# Providence City Plan Commission

March 18, 2025

## AGENDA ITEM 2 ■ 217 ANGELL STREET

Proposed site plan

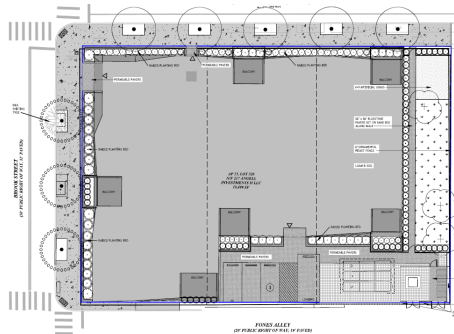
As discussed, the building will front on three streets with Brook Street designated as the front yard, and will address the ascending grade from south to north. Internal structured parking for 42 vehicles will be provided at the cellar level located below the average site grade. Pedestrian access will be provided from Brook Street and vehicular access to the parking area will be provided from Fones Alley. The area adjacent to the western portion of the garage opening will be curbed, with the rest of the Fones Alley frontage uncurbed, which conforms to the site's current condition. An additional three exterior spaces and a loading zone will be located adjacent to the first floor on Fones Alley. The Department of Public Works (DPW) has approved the proposed curbing configuration as it is an existing condition. The transformer and dumpsters will be enclosed and located in the southeast corner of the lot adjacent to the underground stormwater infiltration system.

Based on the average grade calculation, a height of 57' is proposed for which a dimensional adjustment has been requested as it is over the 45' height limit of the zone. The adjustment is within the 12' height adjustment that can be granted by the CPC. A front setback of 5' is proposed from Brook Street, which falls within the build-to zone of 2.1' and 12.1' from the 7.1' average front yard setback. Corner side setbacks of 10' are required from Angell Street and Fones Alley but 4' and 0' are respectively proposed through a dimensional adjustment. A landscaped rear yard with a rear setback of approximately 21'3" will be maintained where 30' is required. The adjustments fall within the 10' setback adjustments that can be granted by the CPC. An adjustment for the proposed building coverage of 68.75% is requested where 55% is permitted, and falls within the 25% adjustment that can be granted. The applicant will maintain 74.71% of onsite impervious coverage where 65% is permitted, as an administrative modification which allows up to a 15% modification of dimensional standards was granted by the Department of Inspection and Standards (DIS).

Thirty two parking spaces are required for 32 units and 45 will be provided. Ingress and egress to the cellar parking area will be provided from Fones Alley which will contain 42 spaces. Three of the 32 spaces used to meet the parking requirement will be compact, within the 10% permitted by the ordinance. An additional 11 compact spaces will be provided. Nine alternating rows of compact and standard sized spaces will be provided. Three additional outdoor spaces with electric car charging facilities will be provided on Fones Alley with a loading space. The loading space is required due to the building's total area which exceeds 40,000 SF and triggers the loading space requirement.

Approximately 5,850 SF of canopy coverage is required to meet the 30% canopy coverage requirement for the lot. The applicant will meet the requirement using a combination of eight large and three small trees with shrubs providing additional landscaping. Five large trees will be planted on Angell Street with two trees on Brook Street in addition to an existing tree. Shrubs in planting beds will be provided around the perimeter of the building. The rear yard will be landscaped with pervious surface and an additional three small trees for a total of 8,900 SF. The applicant will meet the canopy coverage requirement and the street tree planting shall be subject to the City Forester's approval. The Forester requires that the applicant shall be responsible for street tree maintenance.

1. The drainage plan shall be subject to the City Engineer's approval.
2. The planting of the street trees shall be subject to the City Forester's approval. The applicant shall be responsible for maintenance of all proposed street trees.
3. In accordance with the applicant's offer:
  - i. Rental of dwelling units to undergraduate college students shall be prohibited. Undergraduate college students may live in owner-occupied units.
  - ii. Rental to graduate students shall only be allowed on upon majority vote of the condominium
  - iii. Fines of \$500 per incident for disruptive behavior or excessive noise in alignment with City noise ordinances shall be imposed, and waivable only by majority vote of the condominium board.
4. Any required encroachment permits shall be submitted at the permitting stage.
5. Final plan approval shall be delegated to DPD staff.
